Stacy L. Balzer
Operating Director
Service Engineering Operations
Ford Customer Service Division

SUBJECT: **Special Field Action 23L04**
Certain 2022 Maverick Vehicles Equipped With a 2.5L I4 Gas/Electric Engine
Vehicle Emissions Control Information (VECI) Label Update

CERTAIN 2022 MODEL YEAR MAVERICK VEHICLES EQUIPPED WITH A 2.5L I4 GAS/ELECTRIC ENGINE — VEHICLE EMISSIONS CONTROL INFORMATION LABEL UPDATE

FIGURE 3

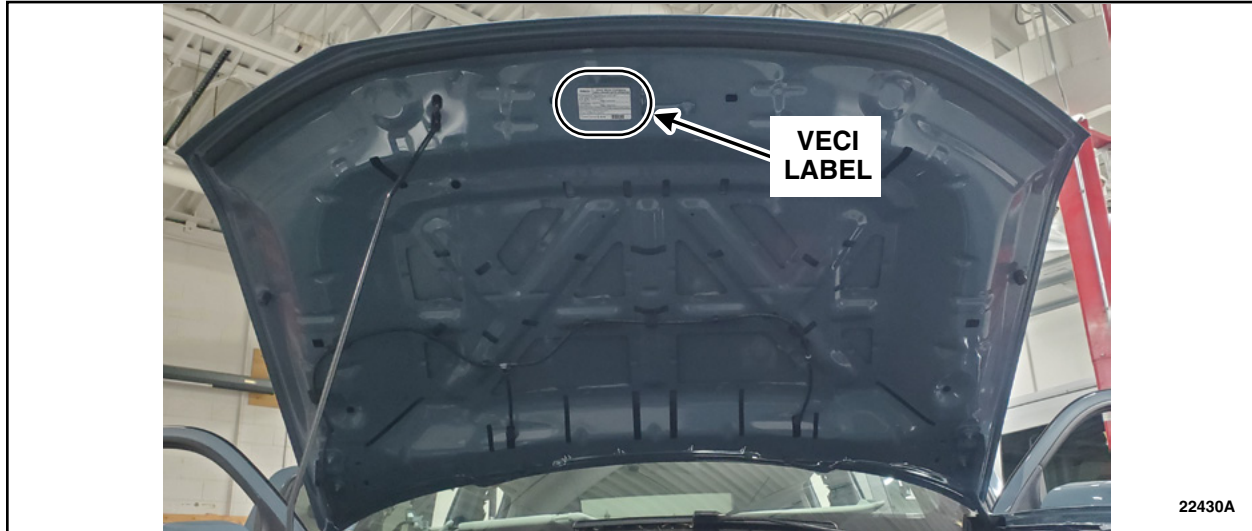
In the affected vehicles, the VECI label lists an incorrect EPA test group.

6. Locate the existing VECI label on the inside of the hood. See Figure 3.

FIGURE 4

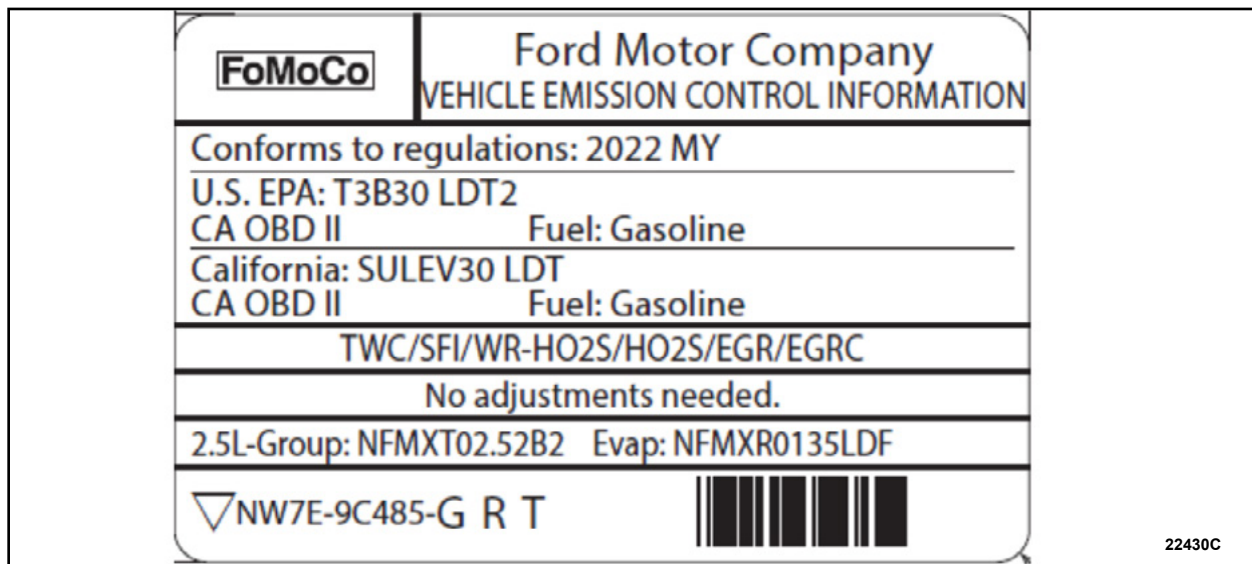
9. Apply the *new* VECI label directly over the original label. See Figure 4.
